ROUNABOUT TYPICAL

PROJECT ID

118356

MED-3-20.63

TRUCK APRON CURB AND GUTTER DETAIL

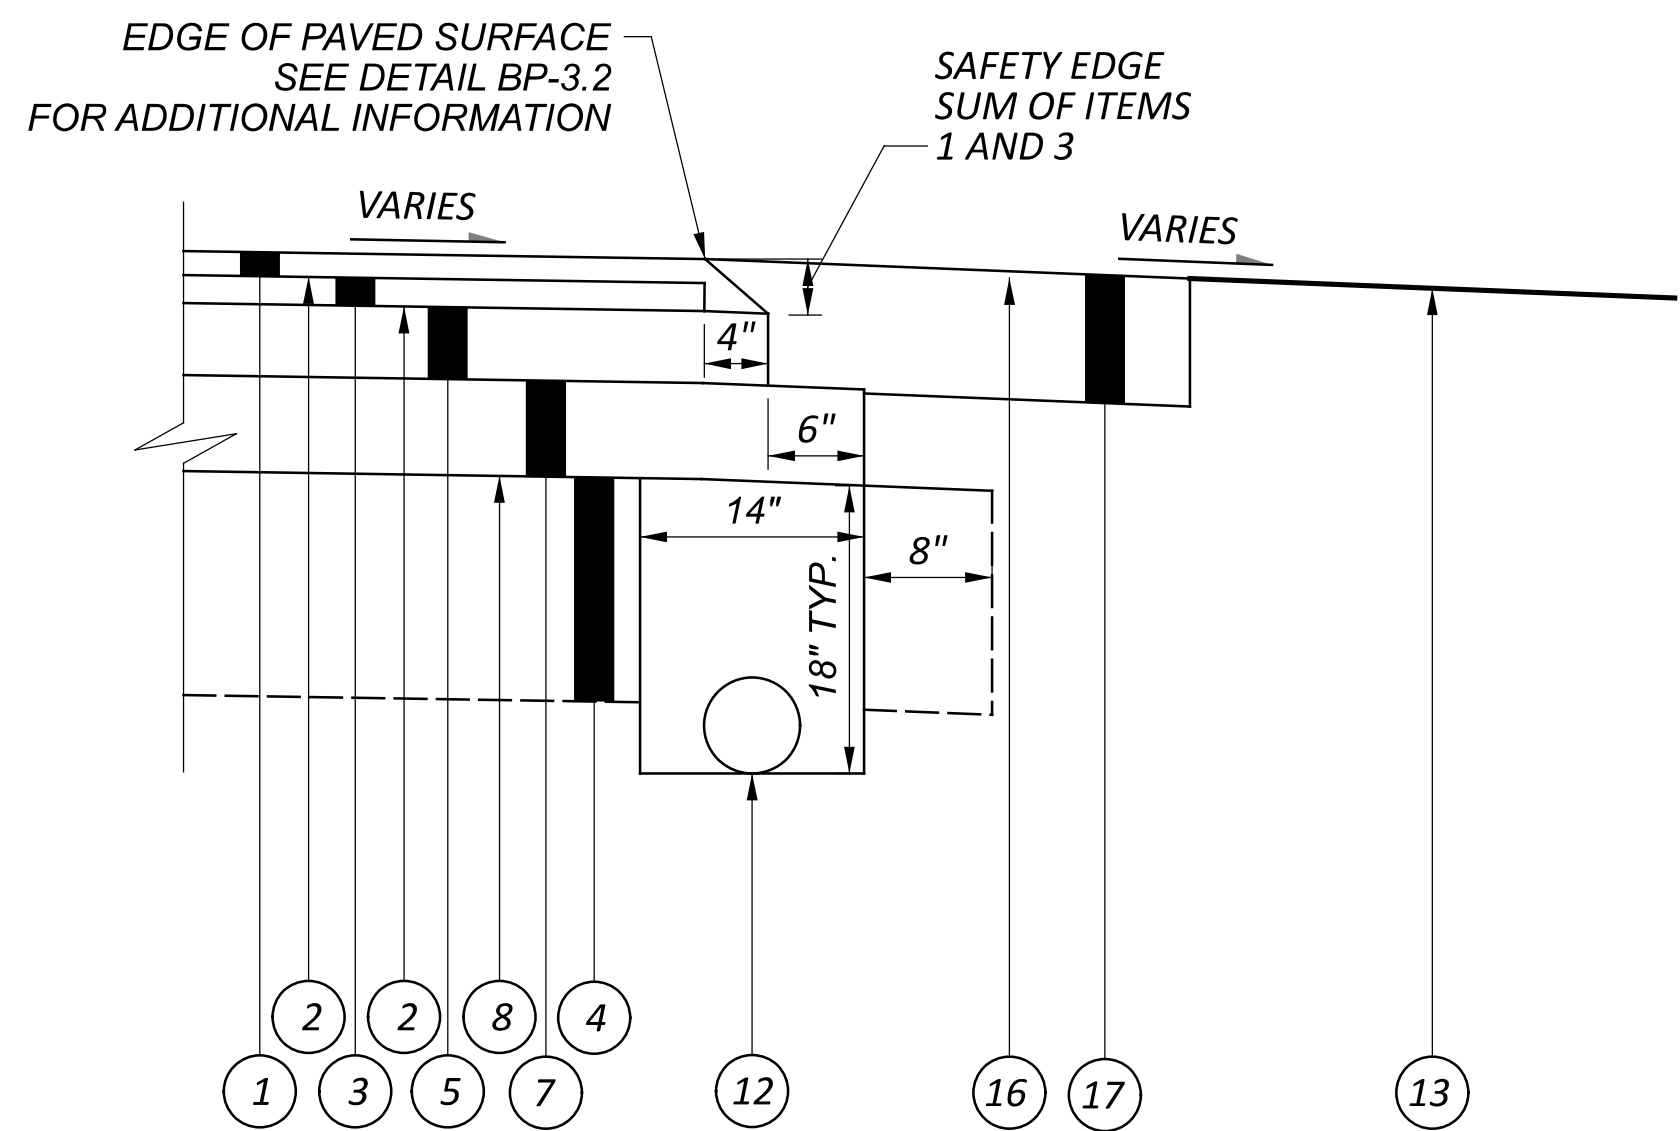
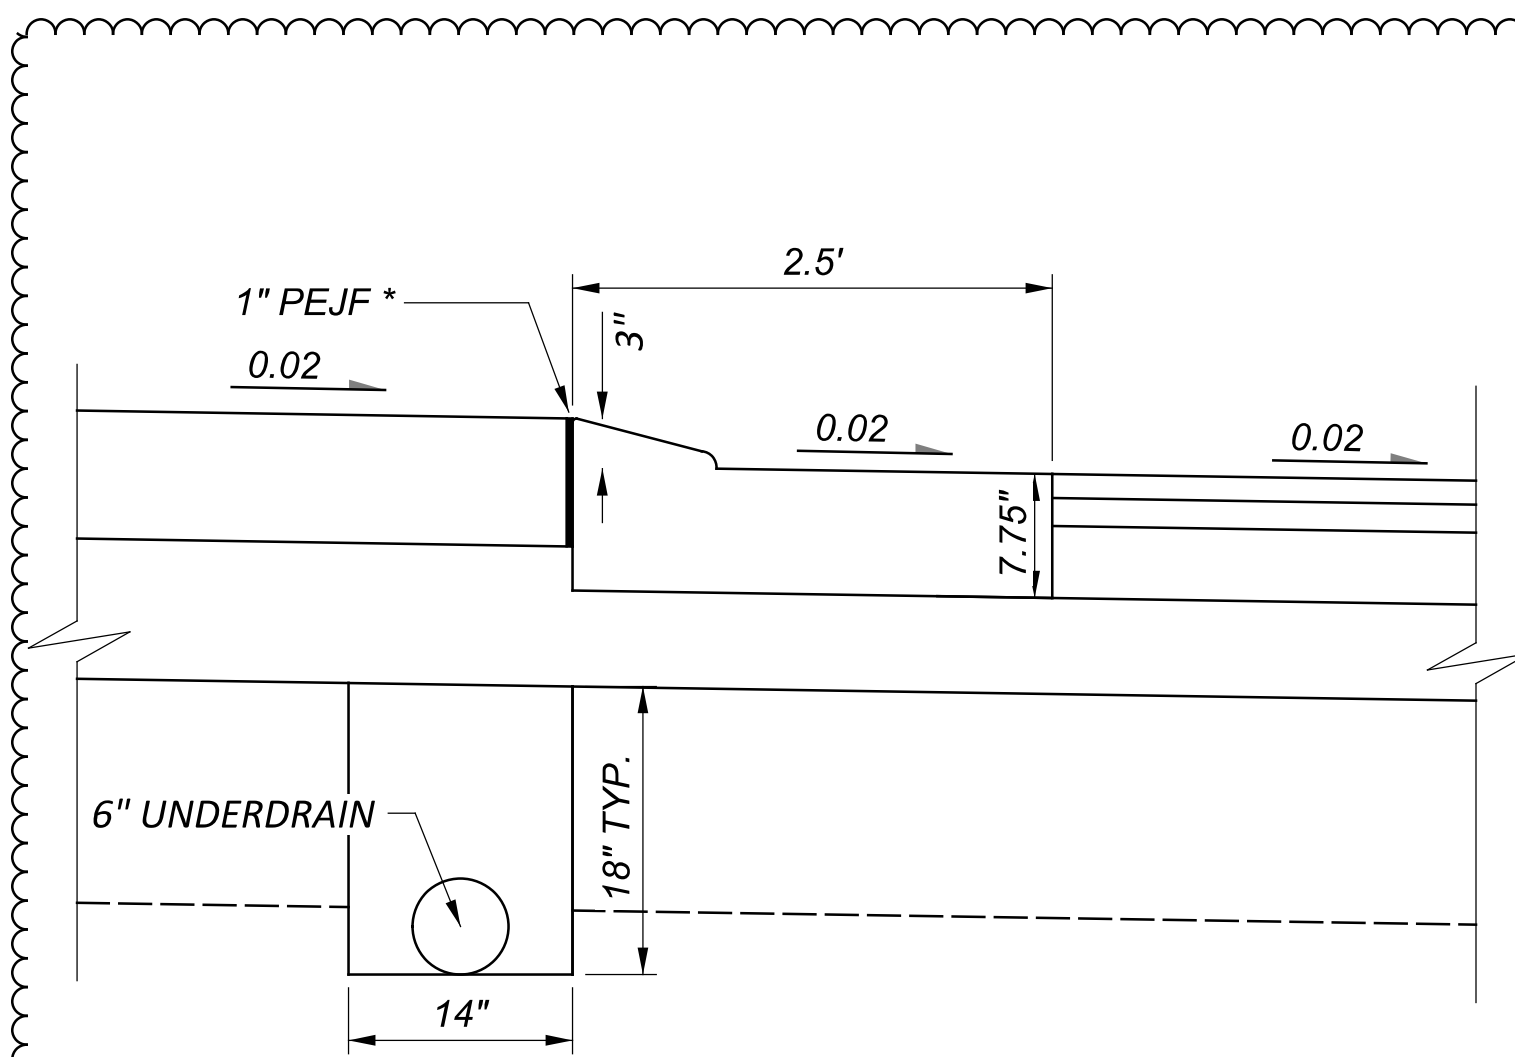
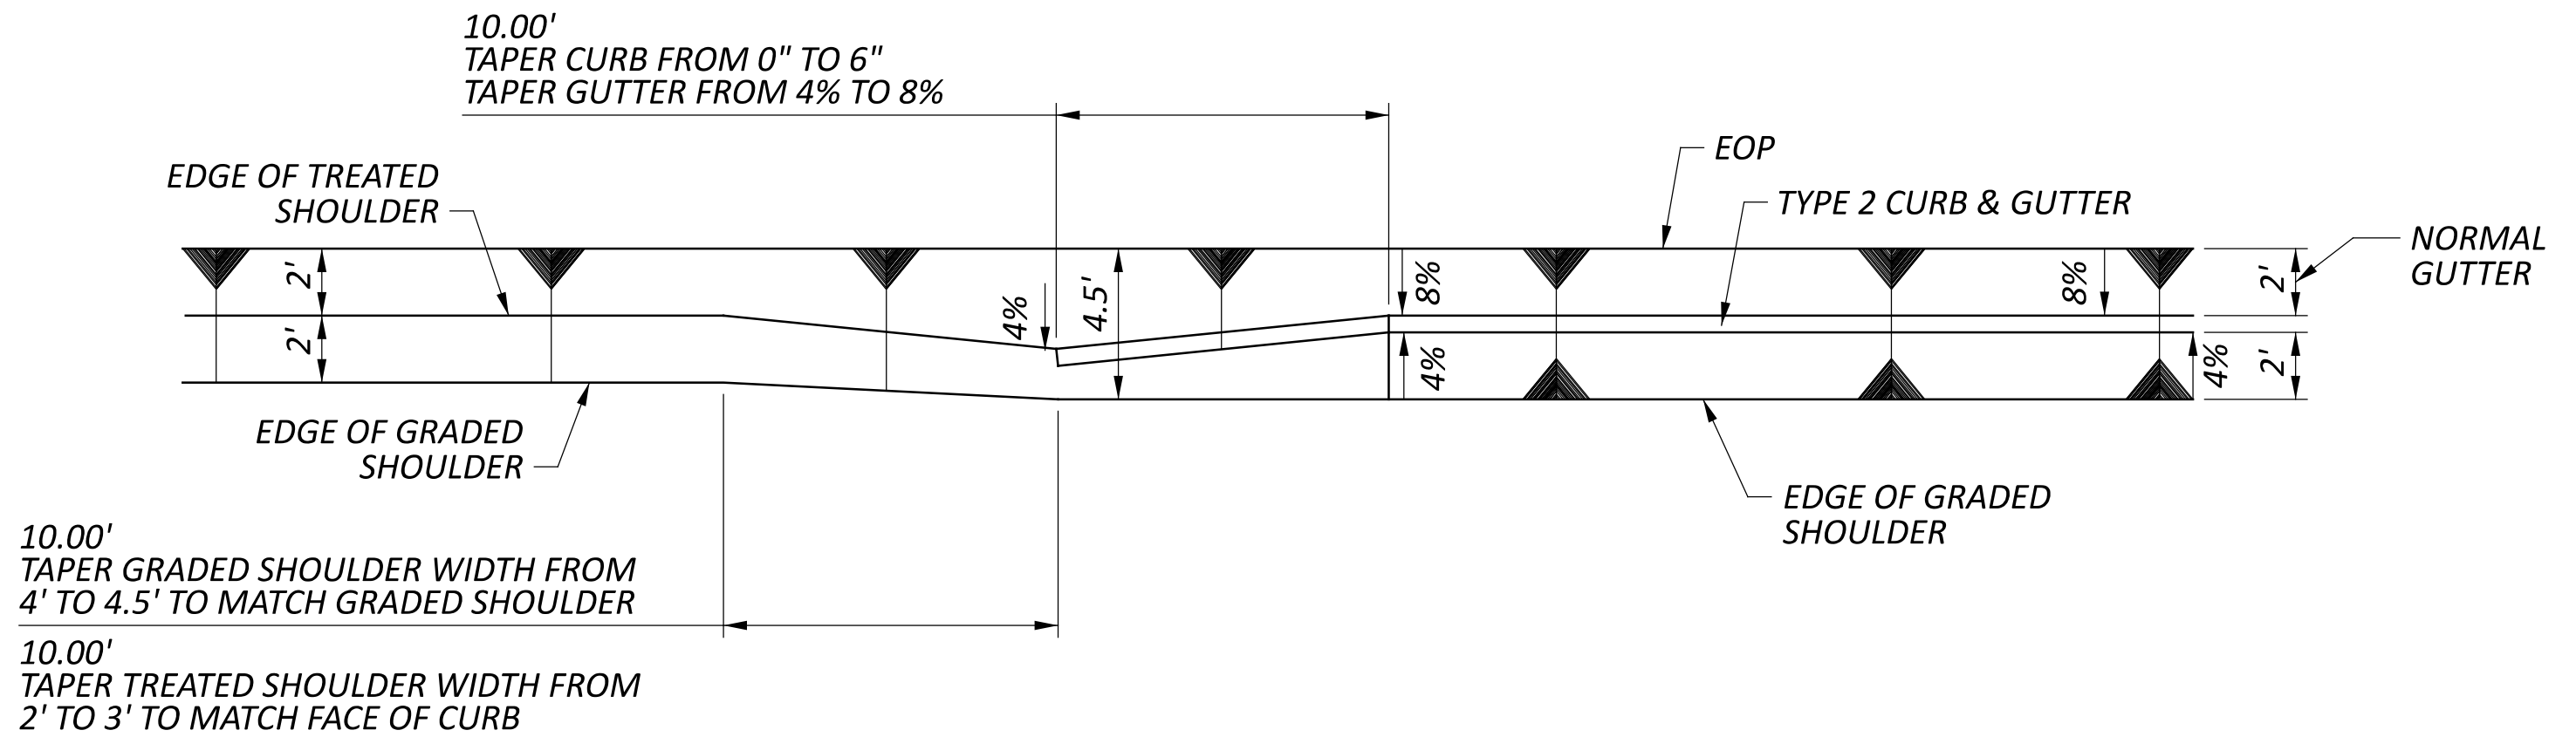
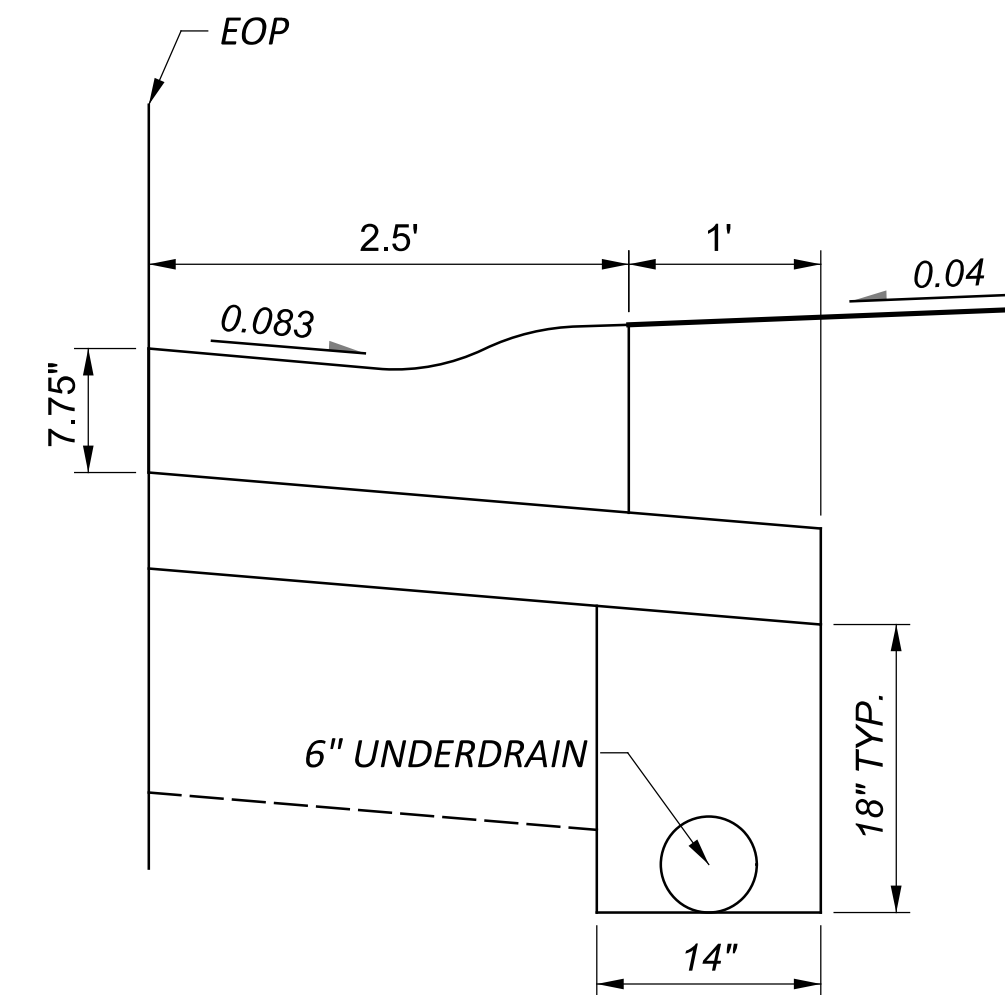
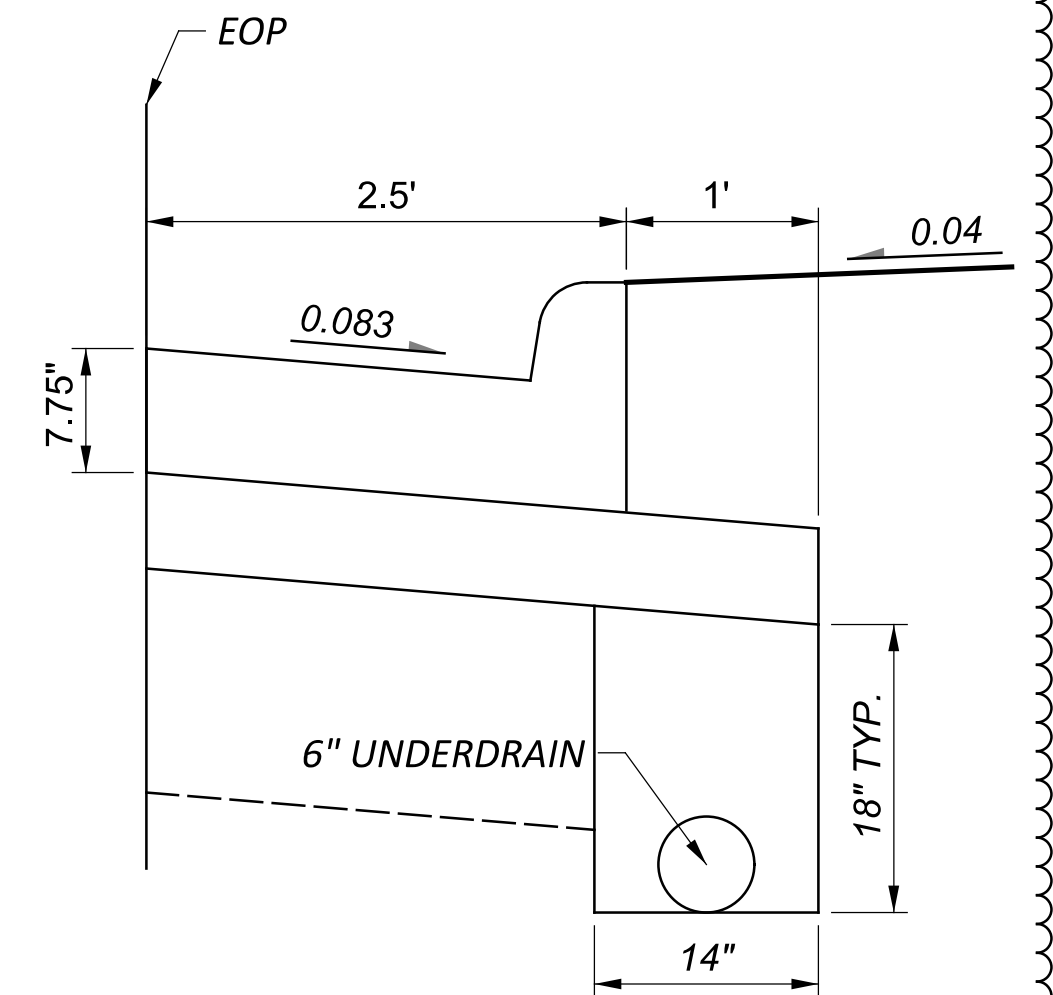
08/20/26 - ALTERED ITEM DESCRIPTIONS, ADDED ADDITIONAL ITEM AND ALTERED CURBS IN THREE DETAILS

PLAN - SR-3 / SR-94
STA. 205+00 TO STA. 210+00

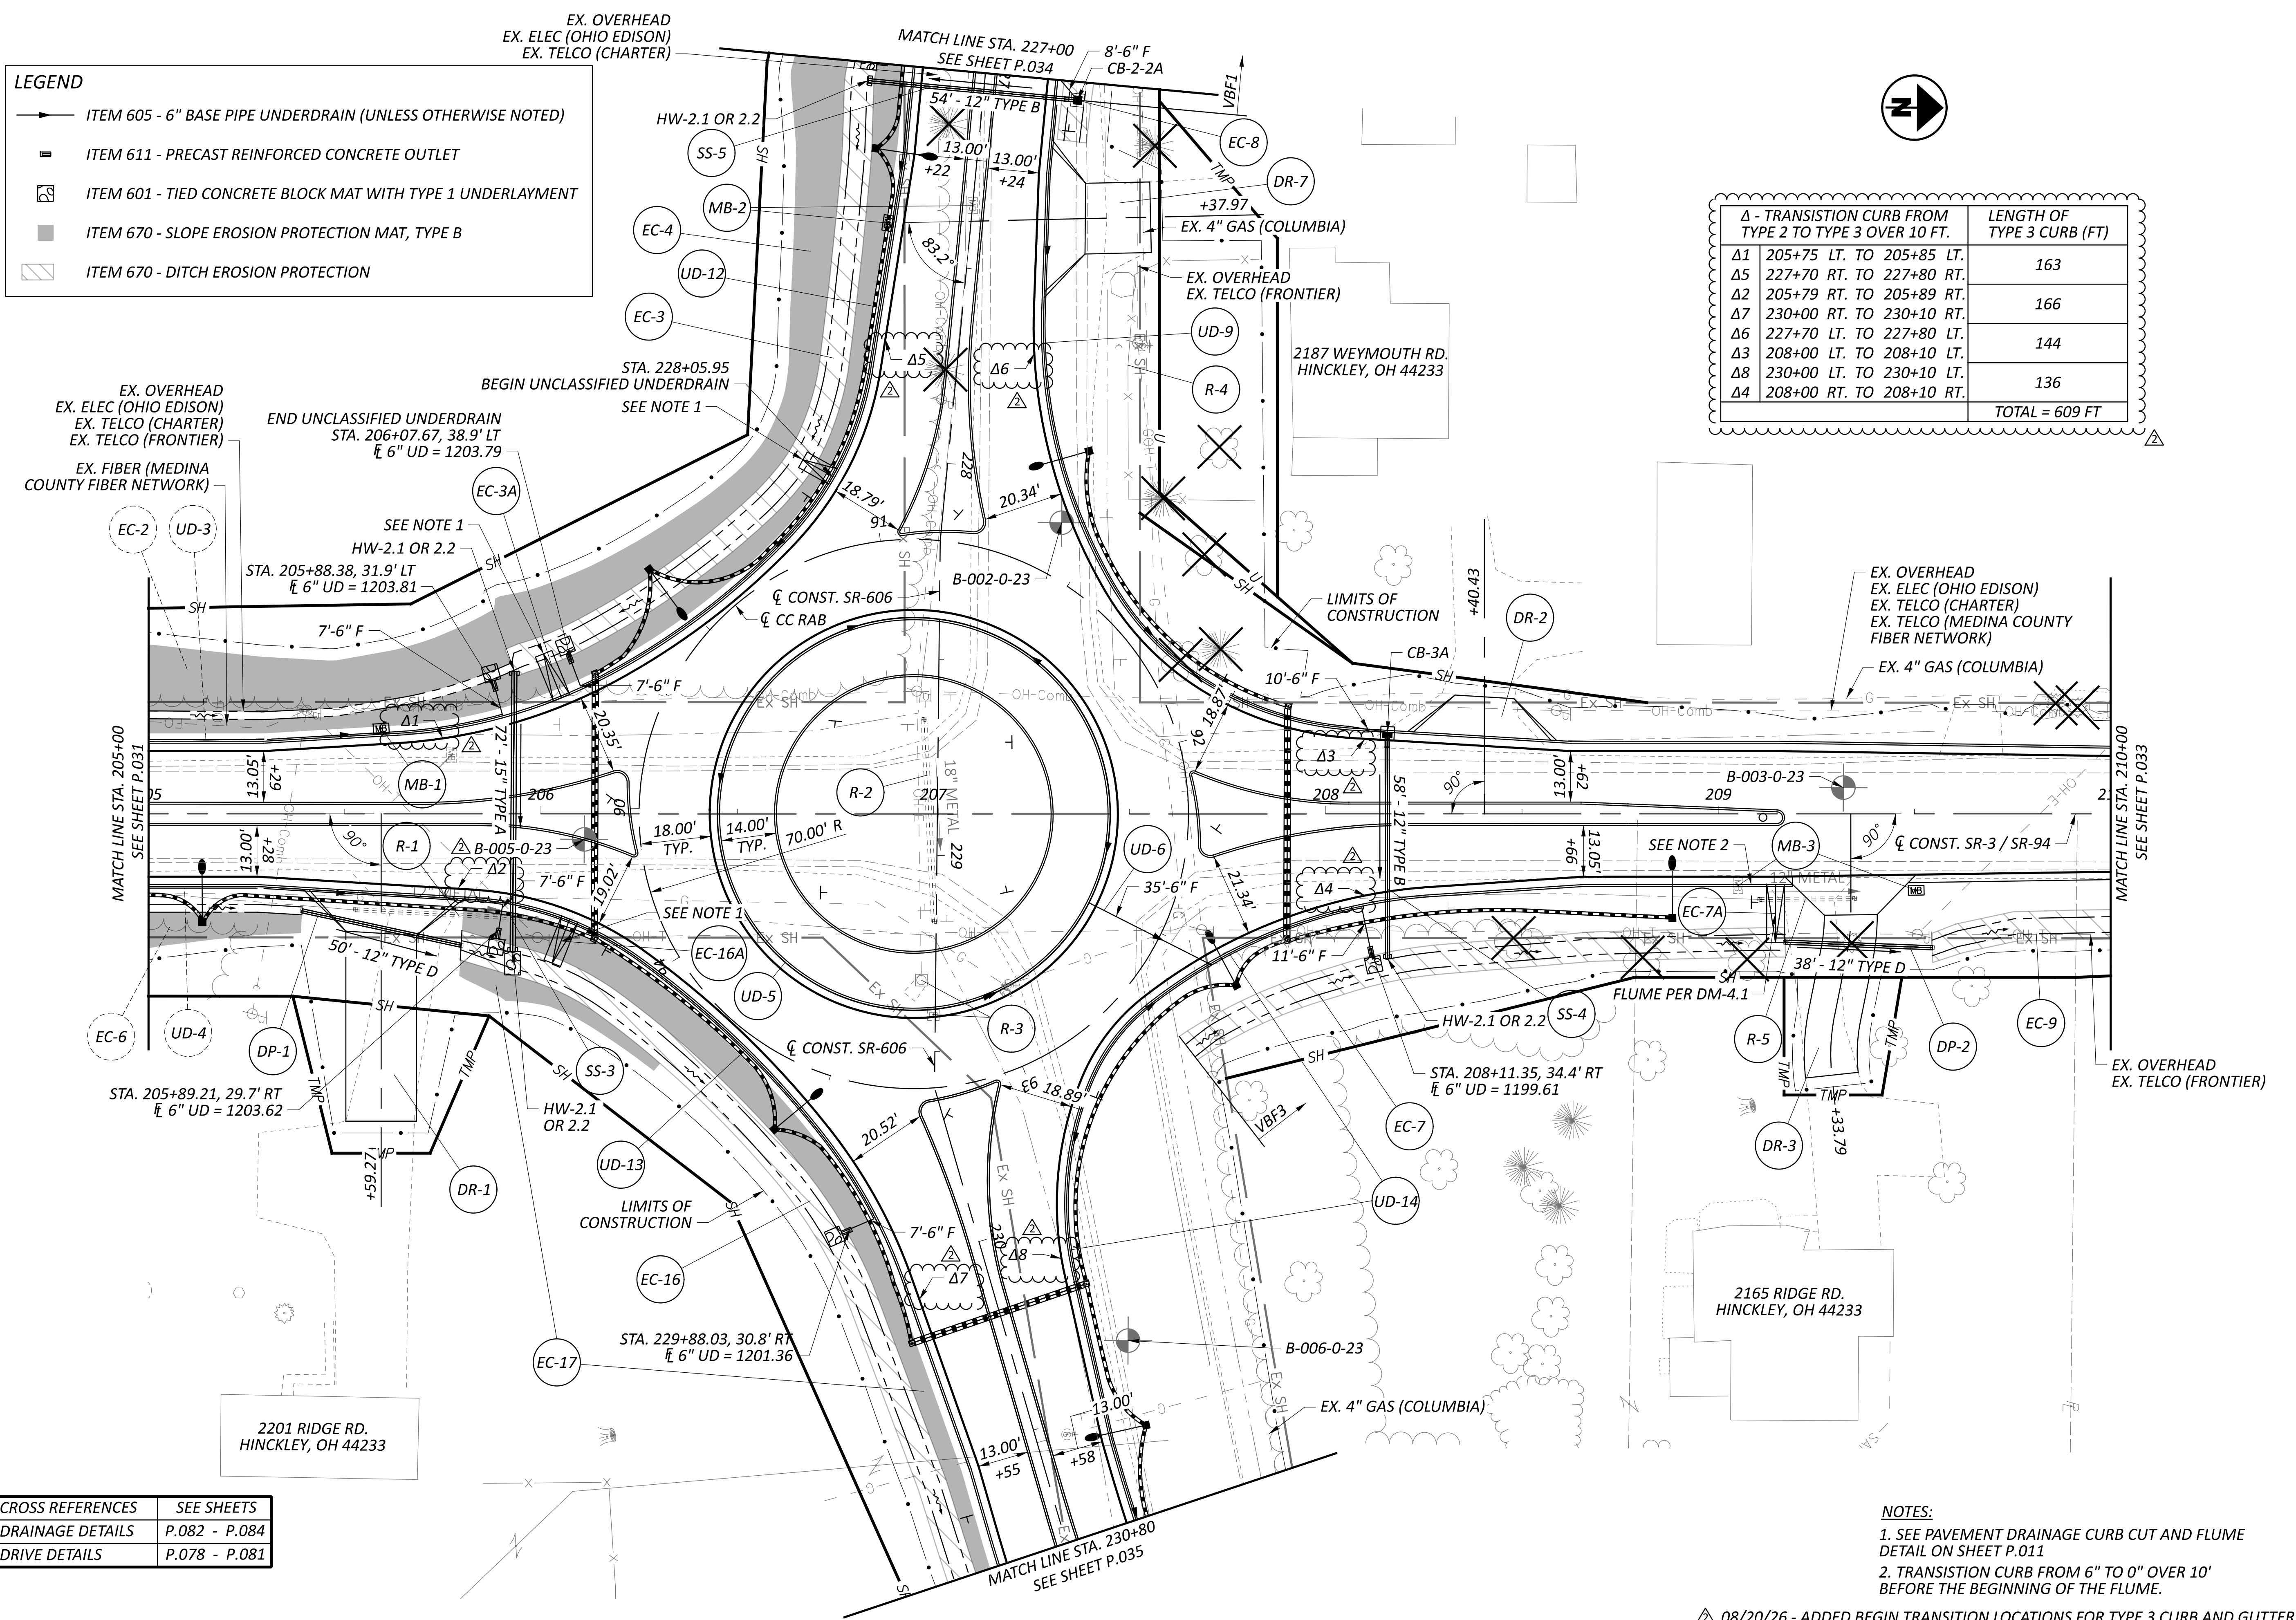
08/20/26 - ADDED BEGIN TRANSITION LOCATIONS FOR TYPE 3 CURB AND GUTTER

Δ - TRANSITION CURB FROM TYPE 2 TO TYPE 3 OVER 10 FT.		LENGTH OF TYPE 3 CURB (FT)
Δ1	205+75 LT. TO 205+85 LT.	163
Δ5	227+70 RT. TO 227+80 RT.	
Δ2	205+79 RT. TO 205+89 RT.	166
Δ7	230+00 RT. TO 230+10 RT.	
Δ6	227+70 LT. TO 227+80 LT.	144
Δ3	208+00 LT. TO 208+10 LT.	
Δ8	230+00 LT. TO 230+10 LT.	136
Δ4	208+00 RT. TO 208+10 RT.	
		TOTAL = 609 FT
